### NOTICE OF VIOLATION

## **INSPECTION REPORT**

Electrical Corporation:	Liberty Utilities					
Report Number:	CAD_LU_CAC17_20241016_0916					
Inspector:	CAC17					
WMP Year Inspected:	2024					
Quarterly Data Report (QDR) Referenced:	Quarter 2 (Q2)					
Inspection Selection:	Energy Safety viewed the contents of the 2024 Q2 QDR and performed an analysis that resulted in the					
	selection of the WMP initiatives and locations referenced in this report.					
Relevant WMP Initiative:	8.1.2.3 Distribution Pole Replacements					
Date of inspection:	October 16, 2024					
City and County of Inspection:	South Lake Tahoe, El Dorado County					
Inspection Purpose:	Assess the accuracy of Liberty Utilities' QDR data, completeness of its work, compliance with WMP					
	requirements, and compliance with its protocols.

Exhibit A: Photo Log **Structure ID:** 296943

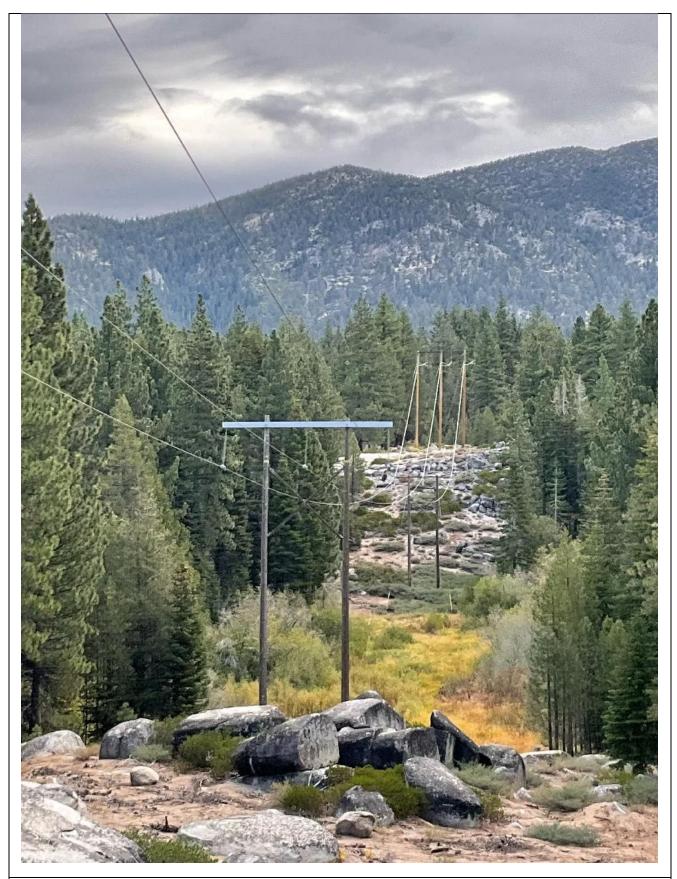
On Pole ID 296943, Grid Hardening ID c08ef8ff-b904-4b2c-9b7a-f5ec4d02185e, near the Meyers substation, South Lake Tahoe, CA, USA (or approximately 2,500 feet due south from 2039 High Meadow Trail, South Lake Tahoe, CA, USA), 38.891428, -119.958043, the inspector observed a transmission-only H-structure where Distribution Pole Replacements initiative work was reported. The inspector's observation is documented in Violation 1 photographs, which are attachments to this report. Photo numbers Item1IA1Img1, Item1IA1Img2, Item1IA1Img3, and Item1IA1Img4 depict a 120 kV transmission H-structure with no distribution lines.

- 1. Liberty Utilities' 2023 WMP Distribution Pole Replacements work was reported as complete at this location.
- 2. No distribution pole was present.
